Classic Park Unit 1

City Plan Commission — July 31, 2025

DESCRIPTION OF REQUEST: The applicant is proposing to resubdivide 5.13 acres of land to create a residential subdivision consisting of twenty-five (25) single-family lots. The subdivision is including 5.01 acres of unplatted land and 0.12 acres of platted land from the Mesquite Hills Unit Four Subdivision. The residential lots will range in size from approximately 5,988 to 7,428 square feet. Drainage will be provided through surface runoff directed to the existing drainage pond adjacent to the subdivision. Primary access to the subdivision will be provided via Copper Hill Place. The subdivision was reviewed under the standards of the current subdivision code.

Waiver, Exception, Modification Request(s)

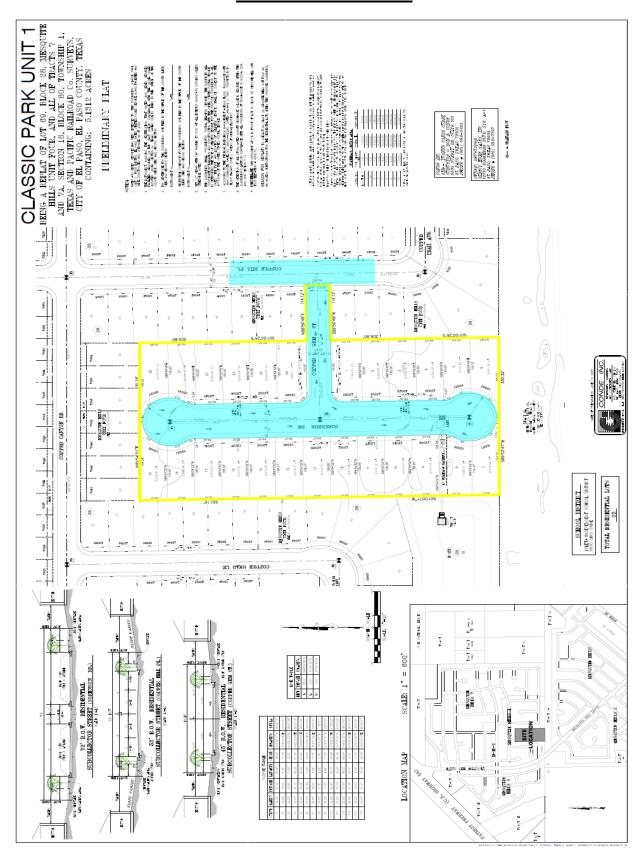
EXCEPTIONS, MODIFICATIONS, OR WAIVER REQUESTS: The applicant is requesting the following exception requests pursuant to El Paso City Code Section 19.48.030 (A) — Criteria for approval of the applicable code. The exceptions include the following:

- 1. To allow the connectivity index to be 0.75 instead of the required 1.4 for the subdivision.
- 2. To waive the construction of two feet (2') of planter strip on each side of Copper Gem St. for a total of four feet (4').

EVALUATION OF EXCEPTION REQUEST: The exception request to waive right-of-way improvements meets the criteria set forth in El Paso City Code 19.48.030(A), which allows for exceptions under special circumstances arising from the physical surroundings, shape, topography, or other features affecting the land, such that the strict application of the code would create an unnecessary hardship or inequity for the applicant. In this case, the exception is requested due to a lot being resubdivided and converted into a local street, resulting in only one point of access to the proposed subdivision. Additionally, surrounding developments constrain the ability to construct a full planter strip without reducing the width of the roadway.

The proposed connectivity of 0.75 is deemed acceptable for this project due to the unique physical constraints of the site. In this case the adjacent developed parcels limit the feasibility of achieving a higher level of connectivity. While the proposed index falls below the minimum standard, the layout still provides reasonable internal access and connectivity to the surrounding street network to support circulation and public access.
